SECTION 00 91 15

ADDENDUM NUMBER 6

- 1.01 DATE: APRIL 6, 2021**
- 1.02 PROJECT: WELCOME CENTER**
- 1.03 PROJECT NUMBER: DCM NO. 2020604**
- 1.04 OWNER: ALABAMA A&M UNIVERSITY**
- 1.05 ARCHITECT: NOLA | VAN PEURSEM ARCHITECTS, PC**

SHEET NUMBER
C701
9 OF 17

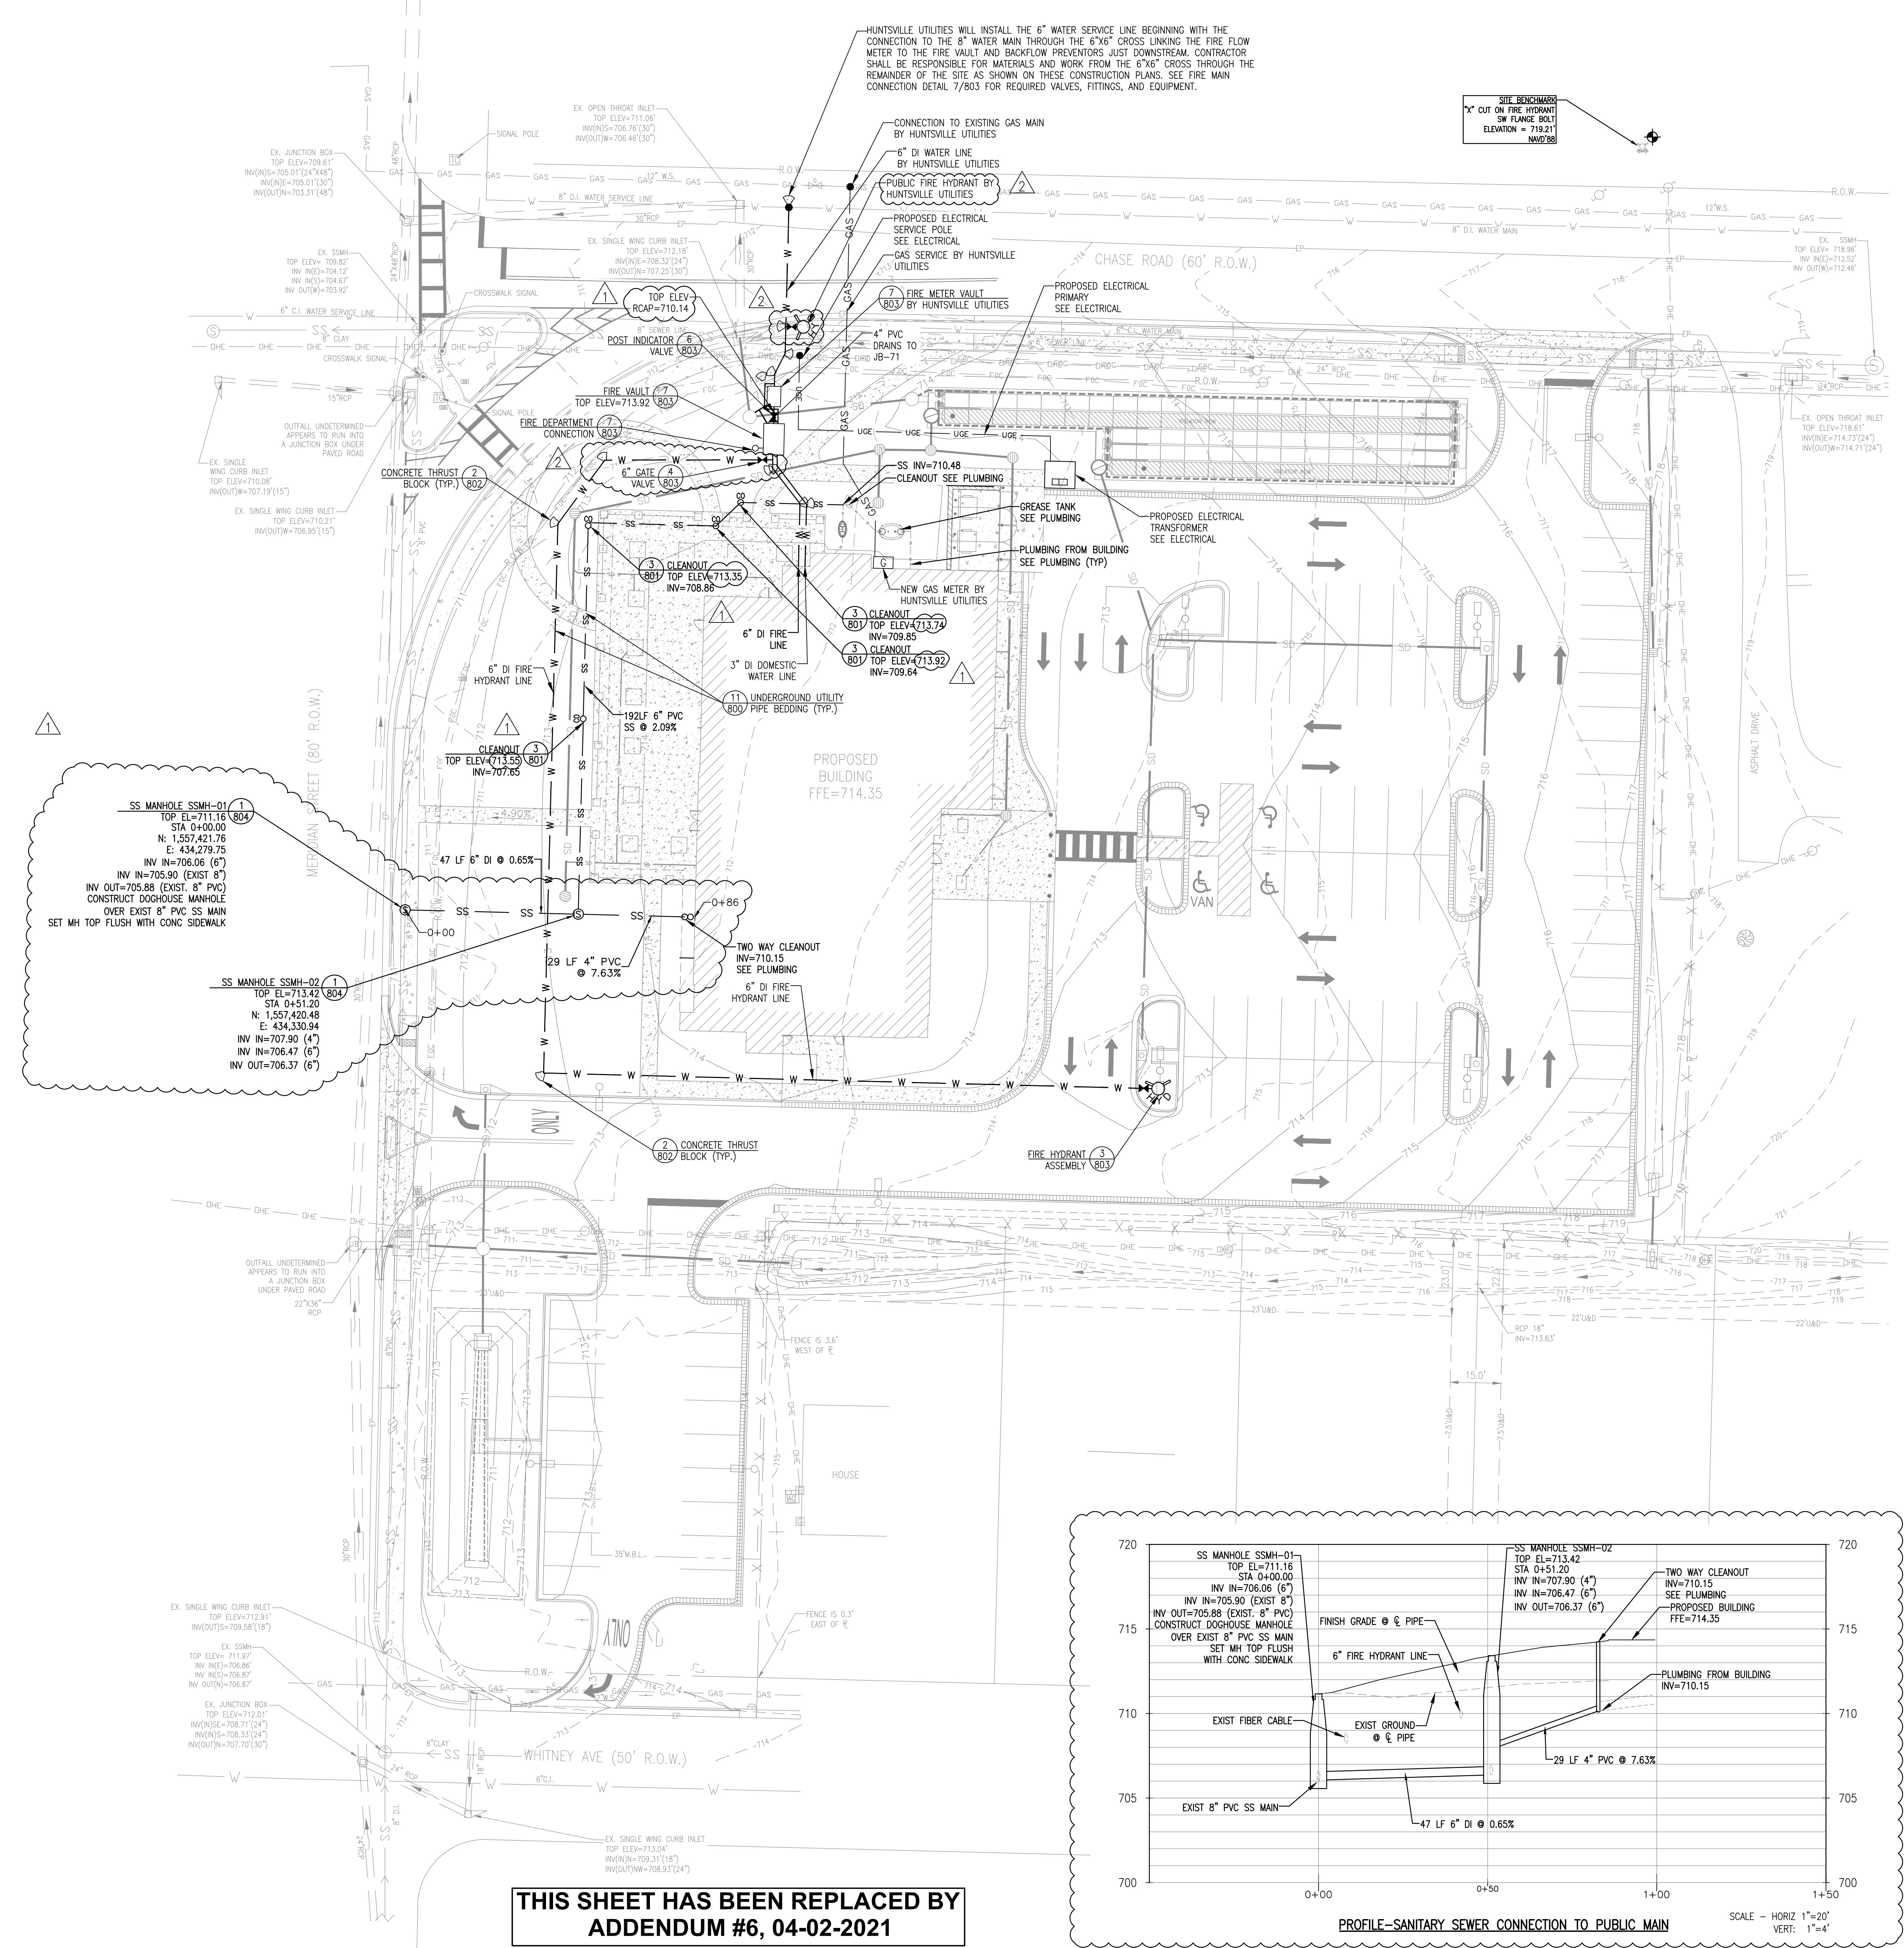
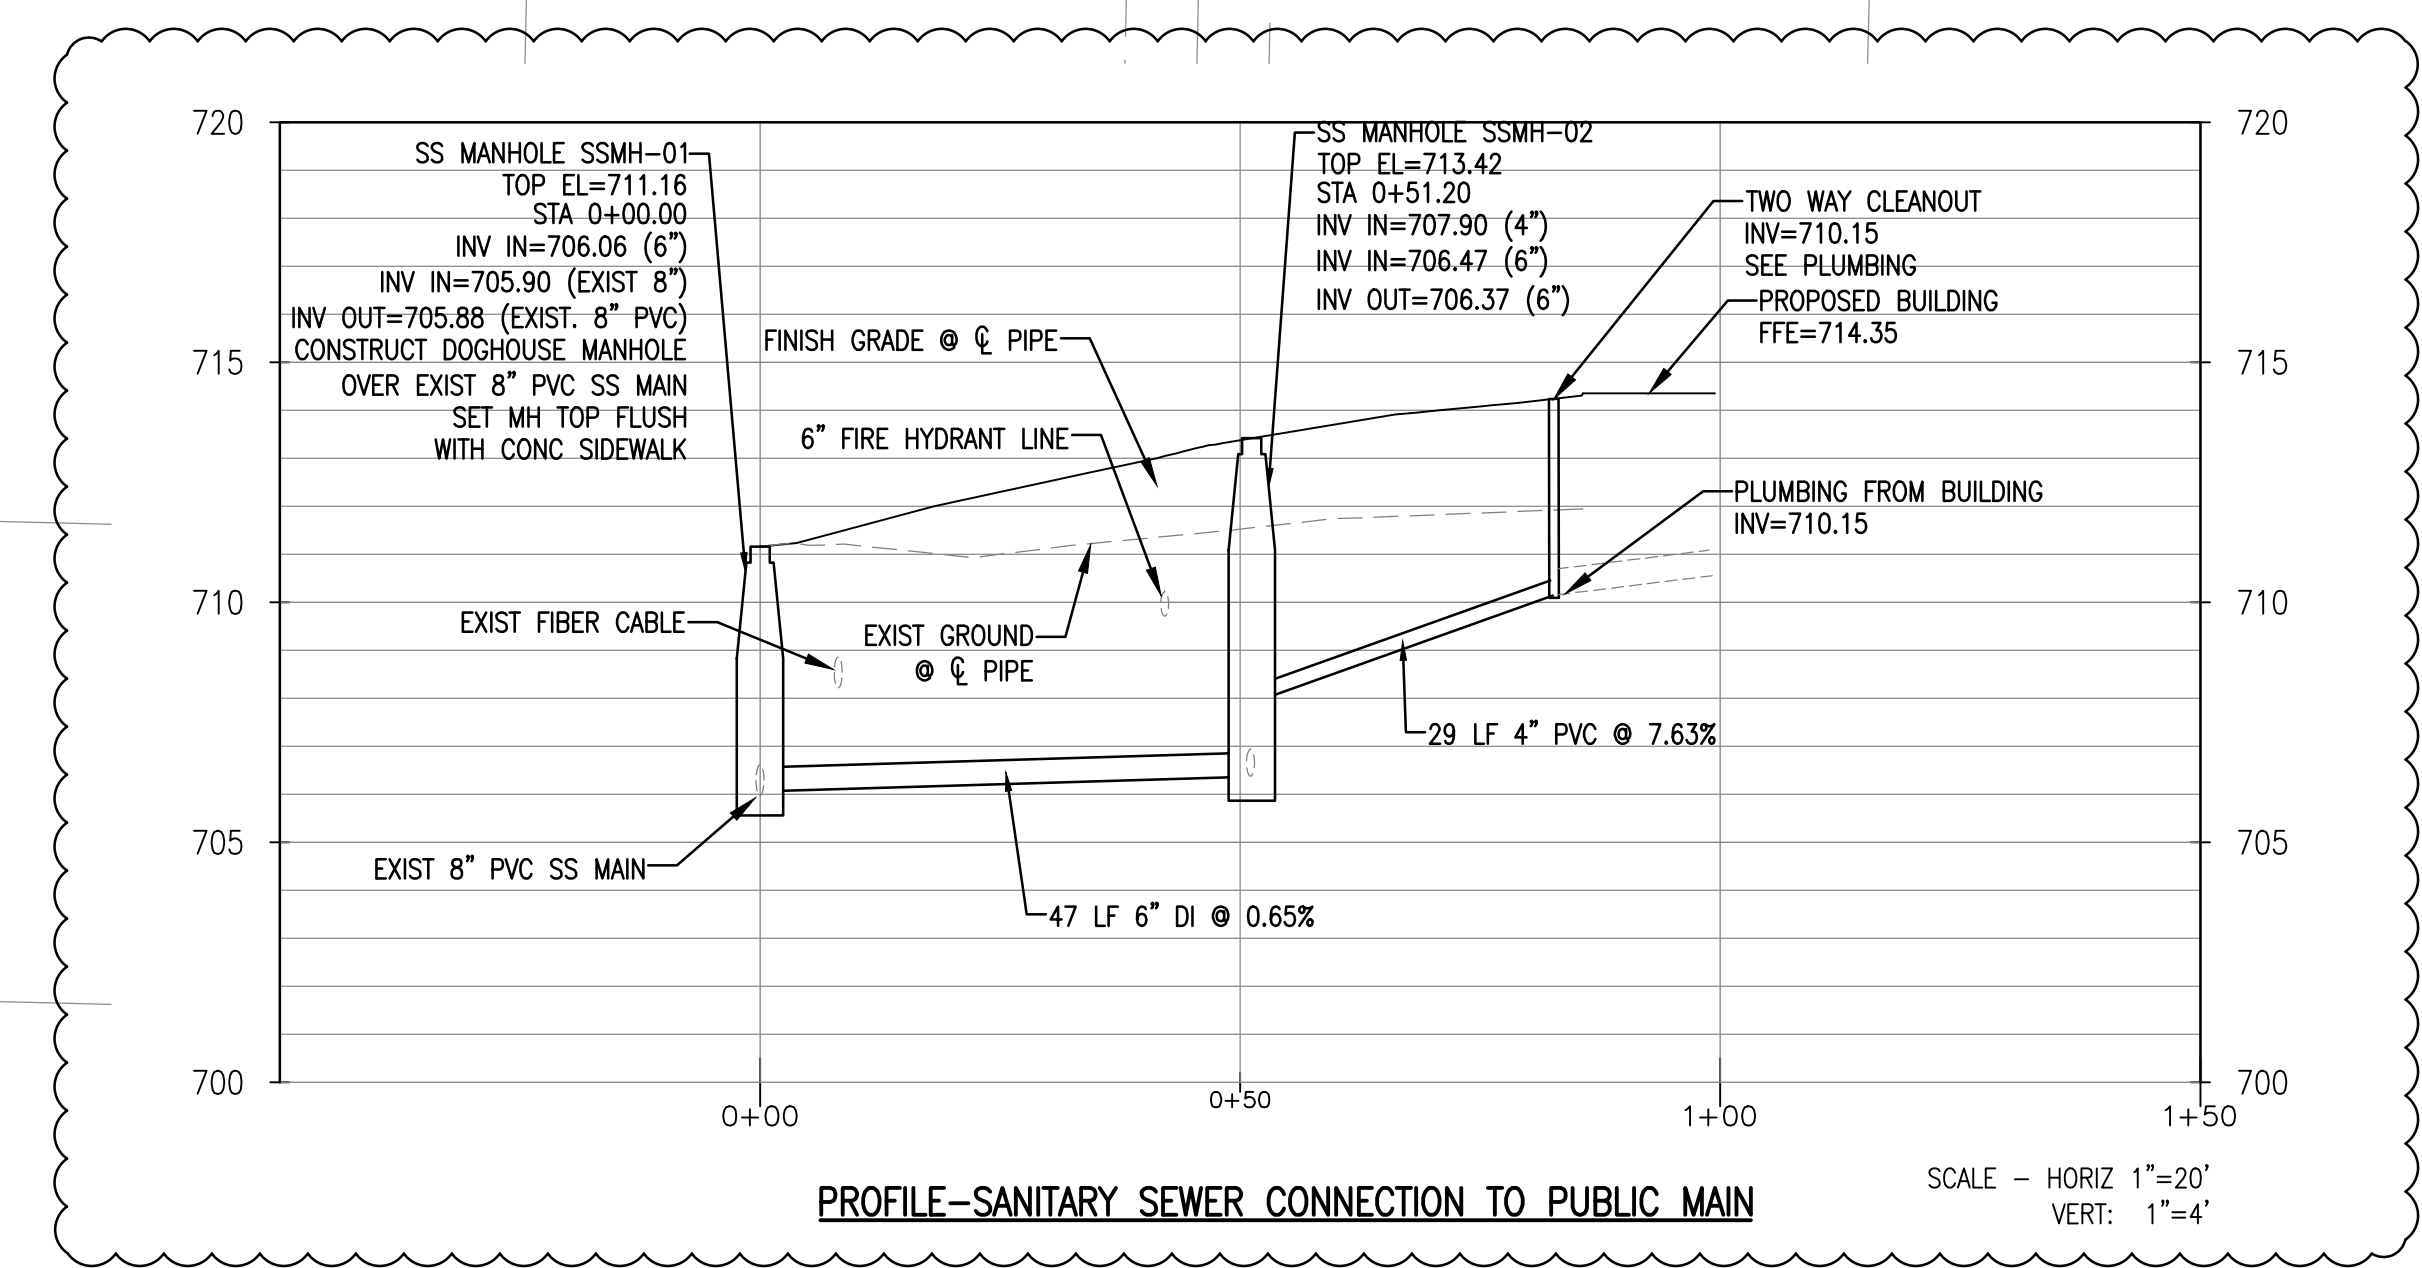
4.02 SHEET C701 – UTILITY PLAN:

- A. Replace this Sheet in its Entirety. Revisions include the following:
1. Changed to show that the public fire hydrant material & installation is by Huntsville Utilities.
 2. Change the connection point for the private fire hydrant line to be on the building side of the Fire Vault.
 3. Changed the route of the private fire hydrant line at the fire vault.
